Deviation From Design

DfD-0014

Taran Laval – SAAA Builder 7417
Van's Aircraft RV7 - 73918

RH ELEVATOR COUNTERSINK ELONGATION

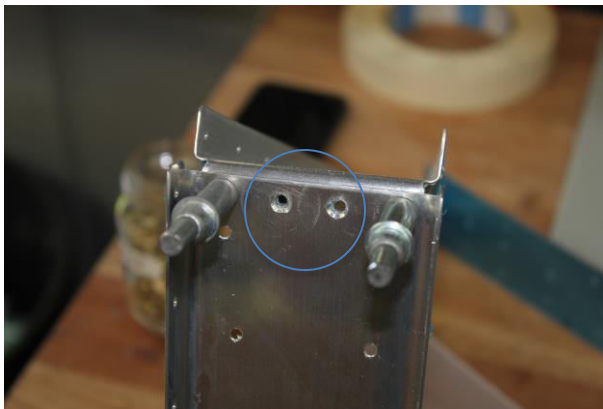
WHILE COUNTERSINKING SPAR 702 TO RIB 709 COUNTERSINK CHATTERED AND OVERCOUNTERSUNK 2 OF THE 4 HOLES

DRILLED 2x 709 IB HOLES TO MATCH AND WILL FIT AN426**AD4**-4 RIVETS
